**TOWN OF NEWBURGH  
PLANNING BOARD  
TECHNICAL REVIEW COMMENTS**

**PROJECT: PEAK SUMMIT SUBDIVISION**  
**PROJECT NO.: 16-13**  
**PROJECT LOCATION: SECTION 17, BLOCK 1, LOT 40.2**  
**REVIEW DATE: 3 OCTOBER 2016**  
**MEETING DATE: 6 OCTOBER 2016**  
**PROJECT REPRESENTATIVE: ZEN DESIGN**

Re: Peak Summit Subdivision  
Fostertown Road  
Section 17 Block 1 Lot 40.2  
Town Project : 16-13

## Comments received from McGoey, Hauser & Edsall, dated 08/23/2016:

**ENGINEER**  
 WILLIAM MOREAU, P.E.  
**PEAK SUMMIT ENTERPRISES, INC.**  
 3 LOT SUBDIVISION  
 MISC. DETAILS  
 FOSTERTOWN ROAD, SBL: 17-1-40.2  
 TOWN OF NEWBURGH, ORANGE COUNTY, NY

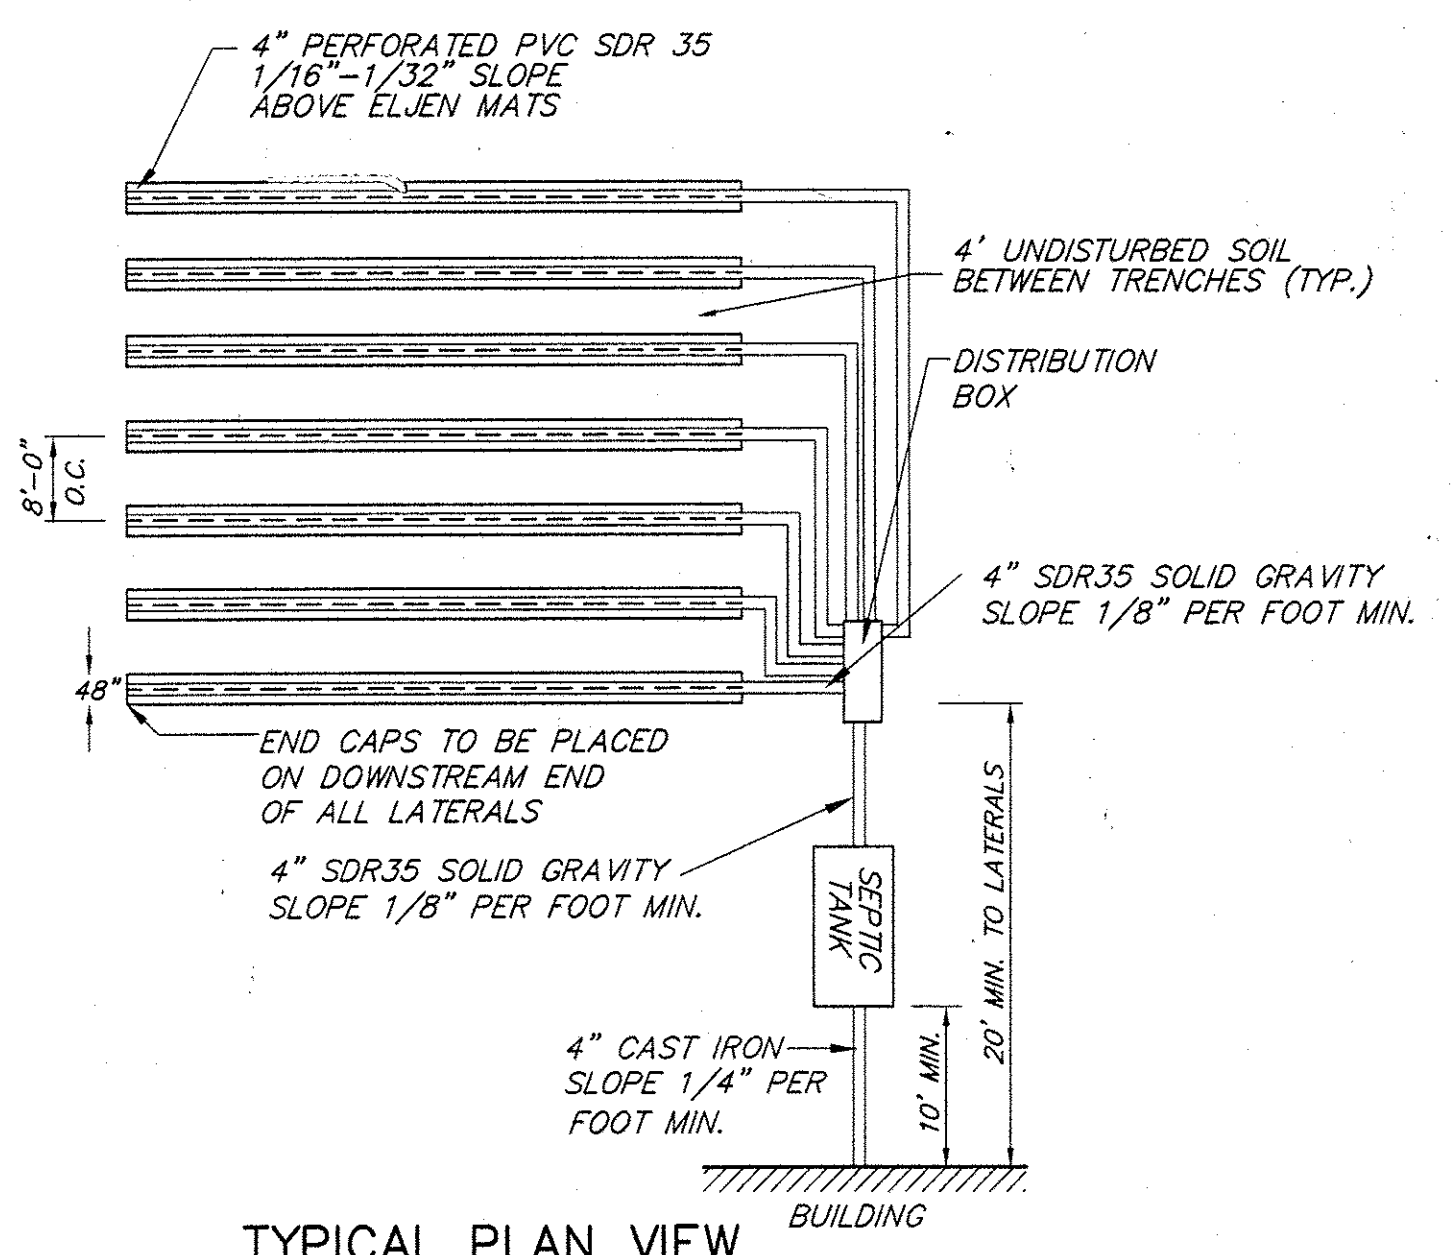
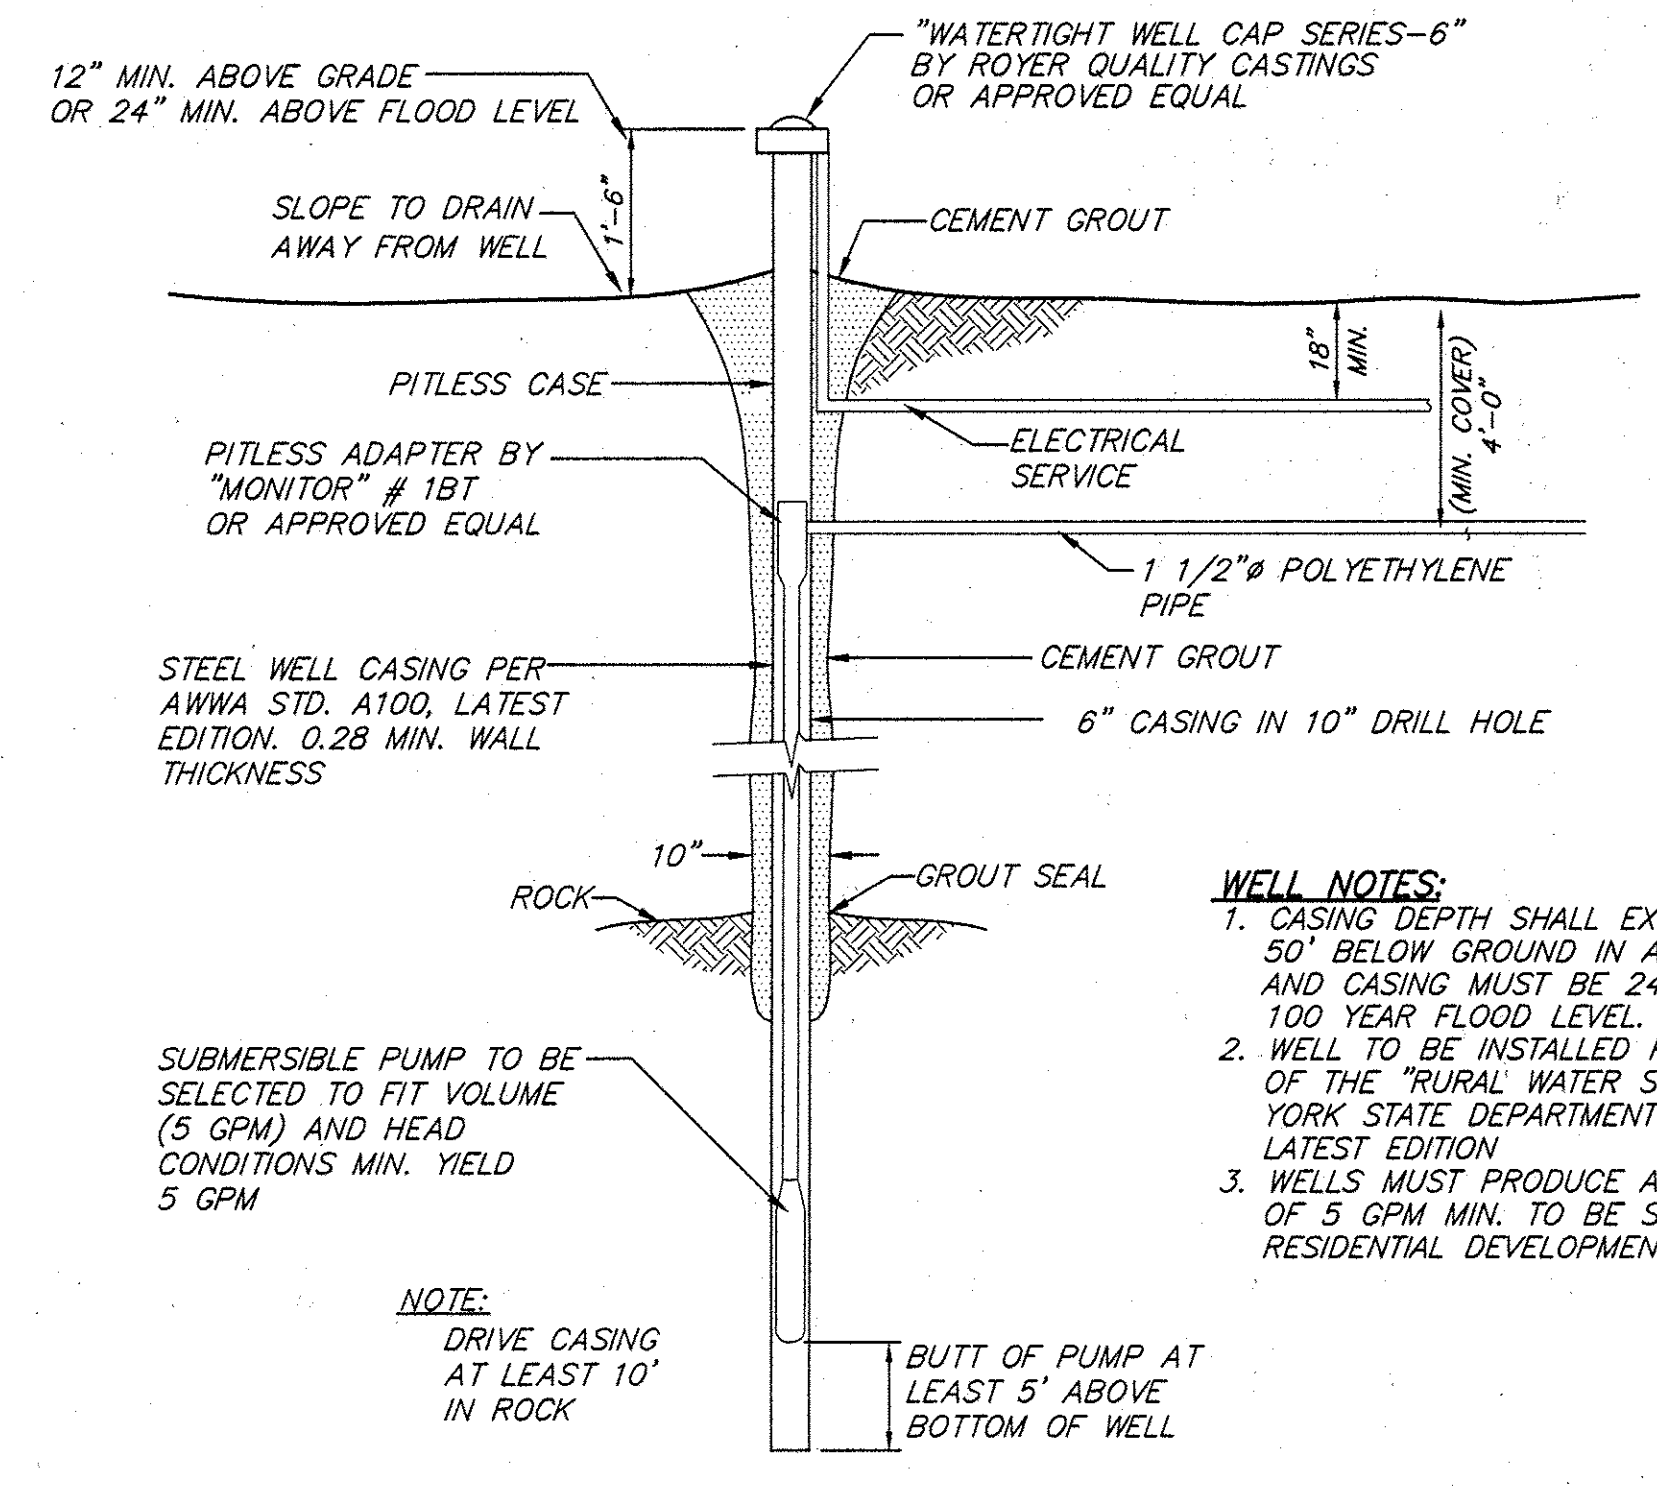
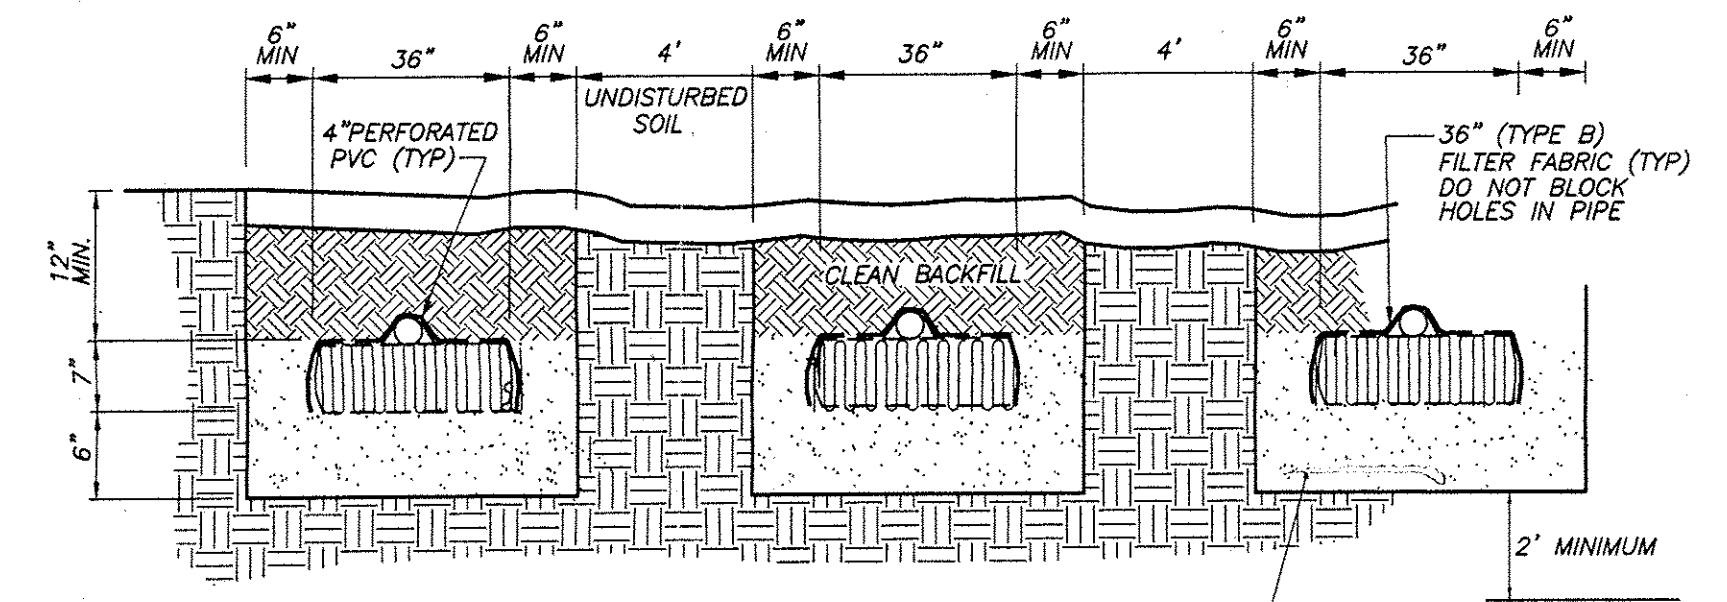
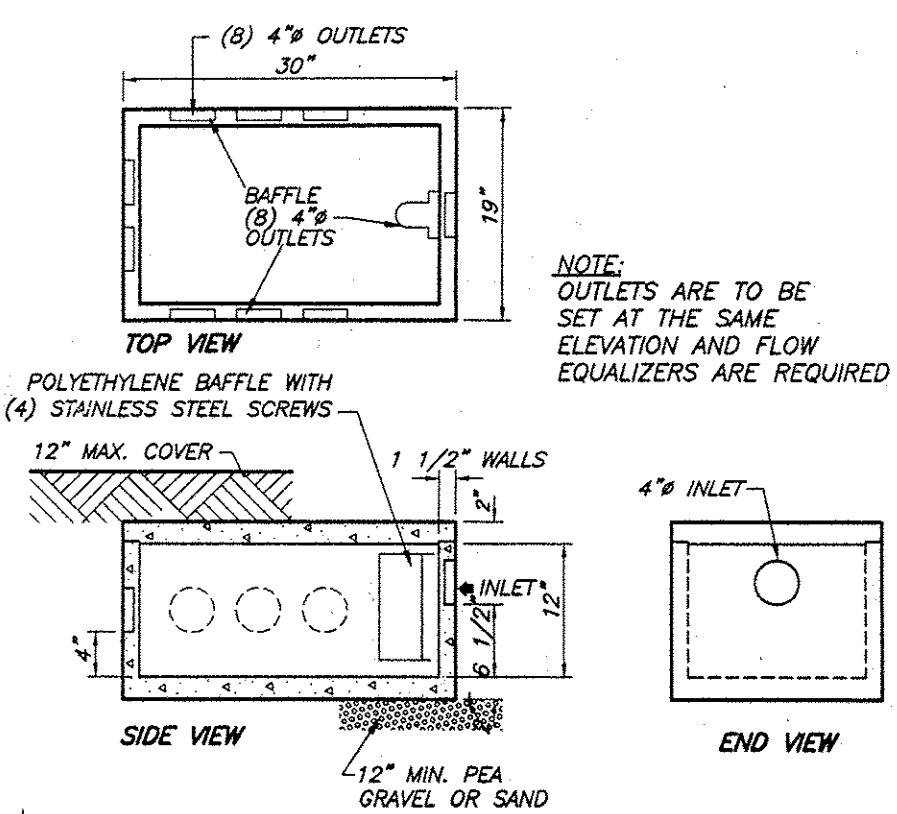
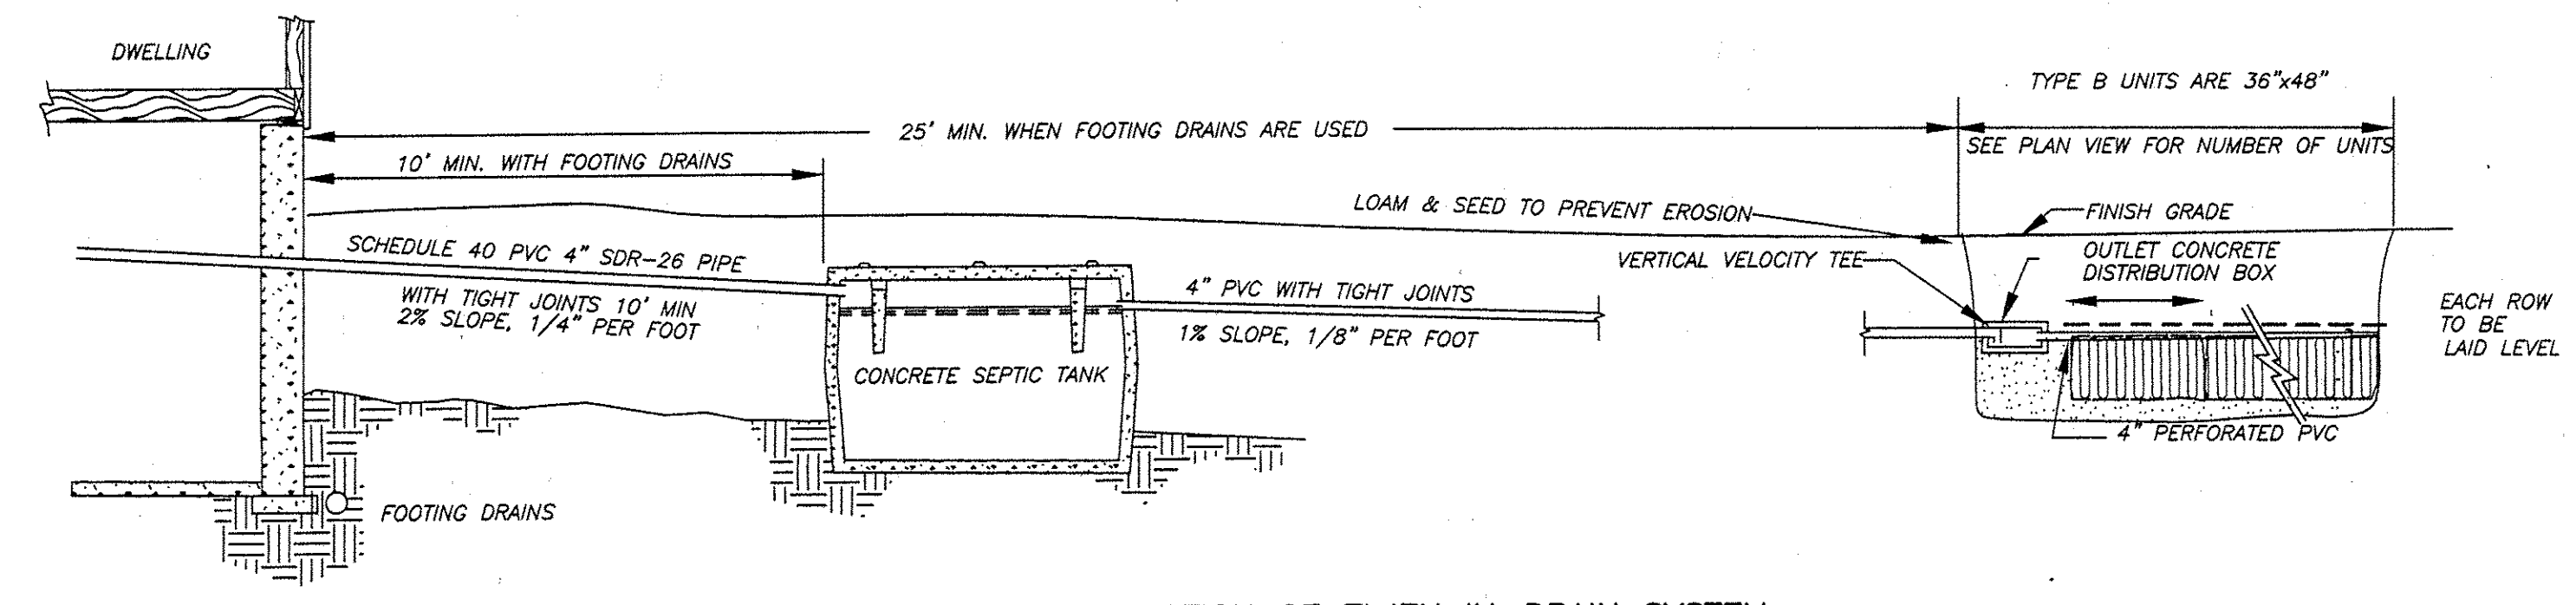
4. Sheet 3 of 4 is identified as septic details while the majority of the septic system details appear on sheet 4 of 4 labeled miscellaneous details.
5. Common driveway access and maintenance agreement approval from Mike Donnelly's office is required.

2. Orange County Planning review and Orange County DPW approval are required as project accesses Fostertown Road/County Rt.86 - **this is understood**
3. Septic design table identifies in ground systems while detail sheet contains what appears to be shallow absorbent trench systems. Shallow absorbent trench notes appear to conflict with elgen system details in some locations - **the details have been adjusted.**
